## **ADDENDUM #1**

**TO: ALL POTENTIAL BIDDERS**  
**FROM: JOSH MEASE, MAINTENANCE DIRECTOR**  
**SUBJECT: PISGAH & TUSCOLA HIGH DINING ROOM A/C REPLACEMENT**

**(RFP# 16-20)**

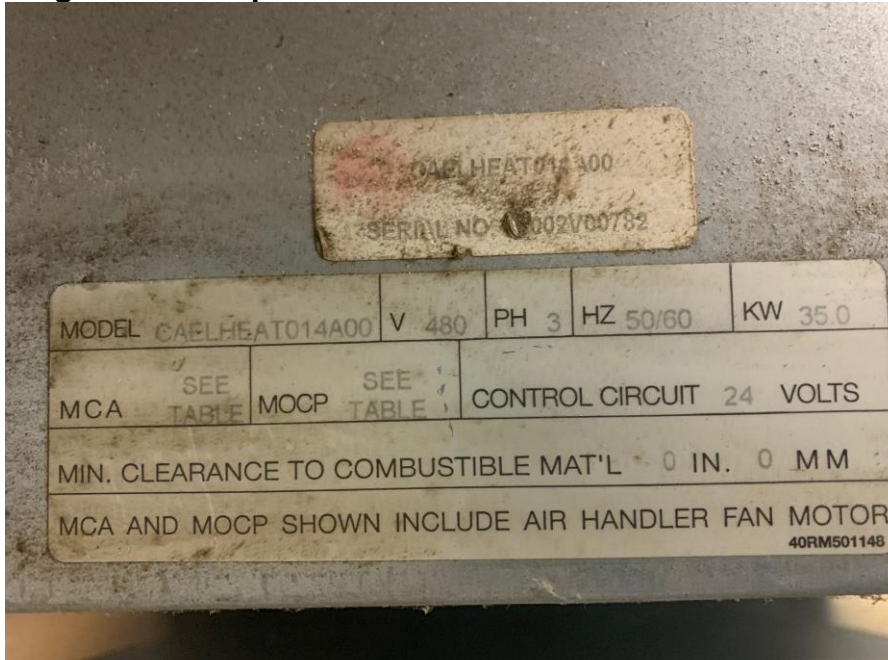
- Page 6 – Pisgah High School Base Bid: 1<sup>st</sup> Bullet 2<sup>nd</sup> Indention remove the words “See attached sketch.”
- Page 8 – Tuscola High School Base Bid: 2<sup>nd</sup> Bullet 2<sup>nd</sup> Indention remove the words “See attached sketch.”
- Units need to be equipped with BACnet.
- In base bid for both schools it should read “High Efficiency Gas Furnaces” instead of
  - Install new Air Handlers and
  - Install new natural gas heater to each Air Handler.
- Alternate #3 will be added to each school to replace systems “Like for Like” as they are now.
  - Pisgah High School a quantity of two (2) 7.5 Ton Heat Pumps with two (2) air handling units and two (2) 35 KW heat strips.
  - Tuscola High School a quantity of two (2) 10 Ton Heat Pumps with two (2) air handling units and two (2) 35 KW heat strips.
- See attached photos containing heat strip model plates for each school.
